# AMENDMENT REPORT

## Tilbuster Solar Farm

Project Number: 20-729

Figure 5-5 Hydrological features surrounding the proposal

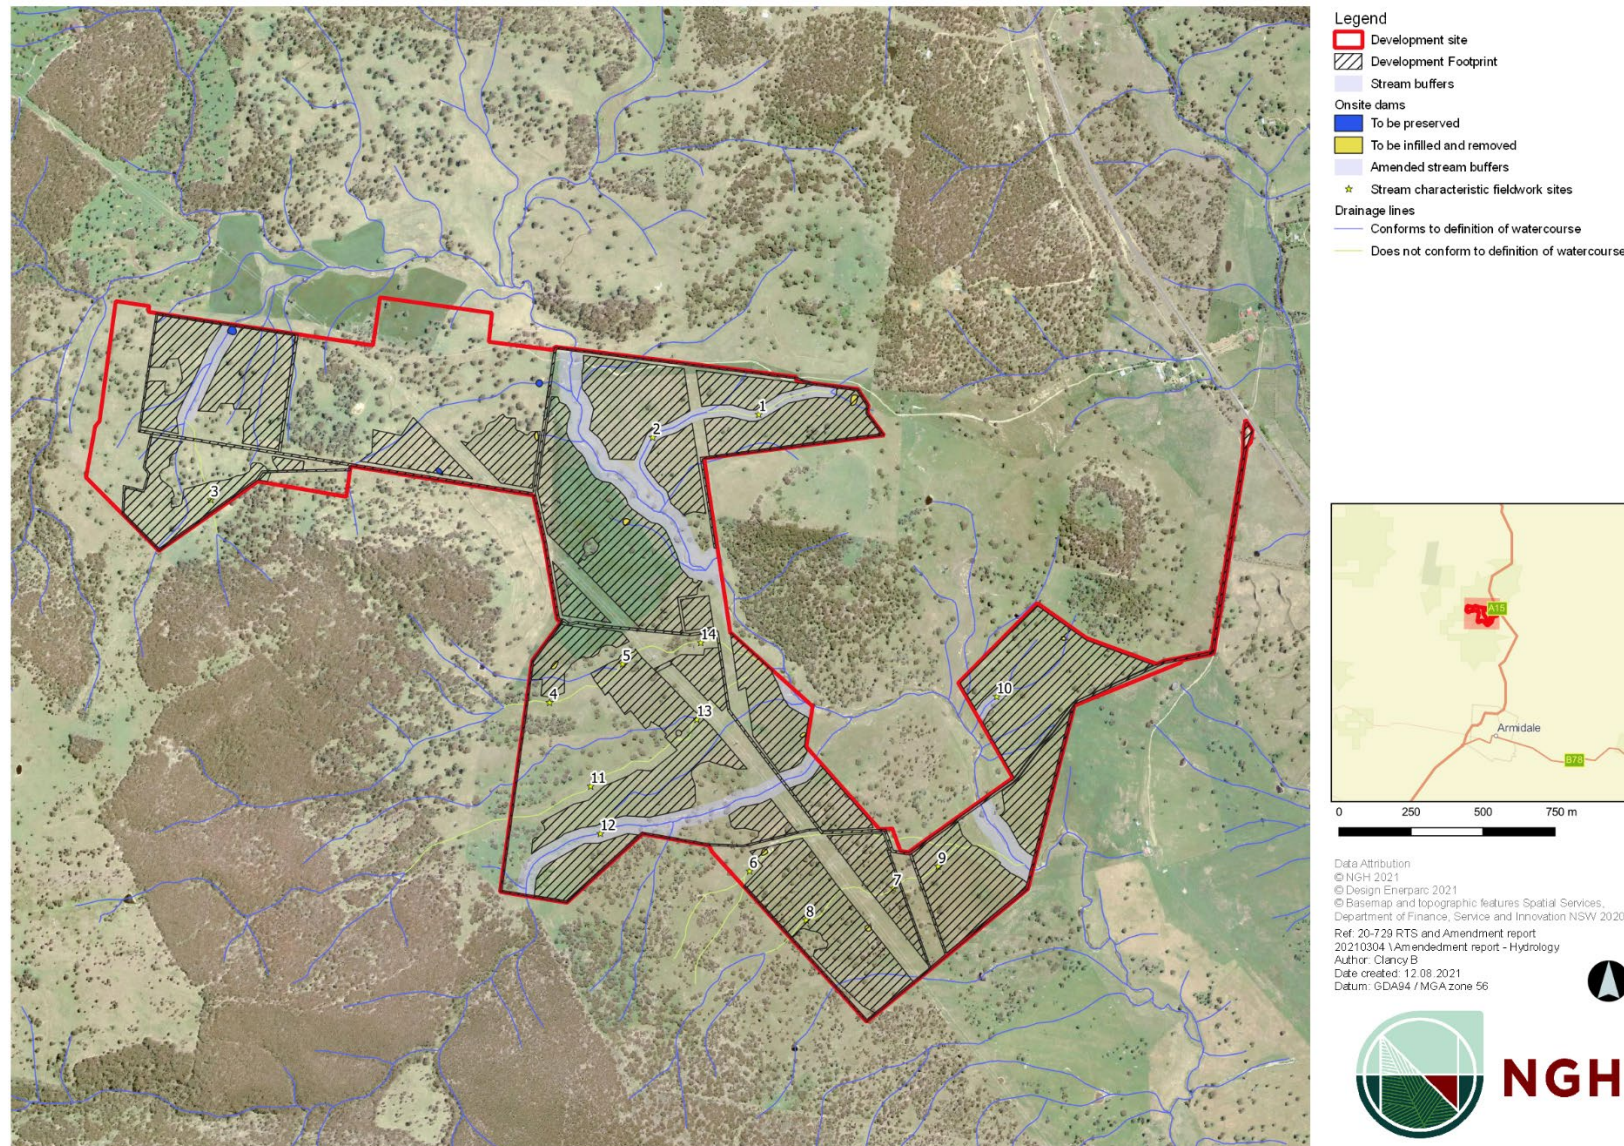
It is acknowledged that development is proposed over some streams currently classified as third order streams. However, neither the subject watercourses, nor any of the watercourses upstream of that point exhibit the typical attributes of a watercourse and the mapping is not an accurate representation of actual conditions and therefore the stream order classification is considered to be overestimated and conservative.

Figure 5-5 identifies the assessment sites and stream locations that under the EIS were assumed to be avoided by the Proposal, but which under the amended Proposal, would be subject to direct impacts.
